From: 김덕수
Sent: Monday, December 07, 2009 4:52 AM
To: PCTEST TCB/CB; 함재준
Cc: 장우태; 장왈운; 김성연; PCTEST - Gregory Czumak; PCTEST - Randy Ortanez; PCTEST - Steve Liu; PCTEST - Mia Kang; 전자메일
Subject: Re: Questions Regarding FCC ID: A3LGTE1155L

RE: FCC ID: A3LGTE1155L

Applicant: Samsung Electronics Co., Ltd.

Subject: Request for additional information

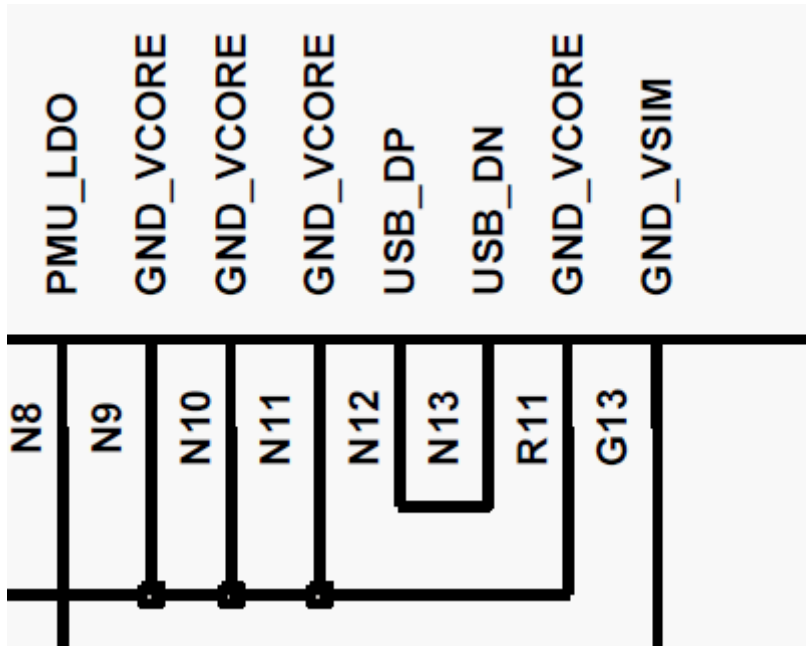
1. Please amend RF photos with correct footer description.
=> Please find the revised photos.
2. The schematics indicate possible USB circuitry. Please clarify and provide JBP report if applicable.
=> This model is not capable of USB. To prevent USB function, USB DP and USB DN are connected as below.
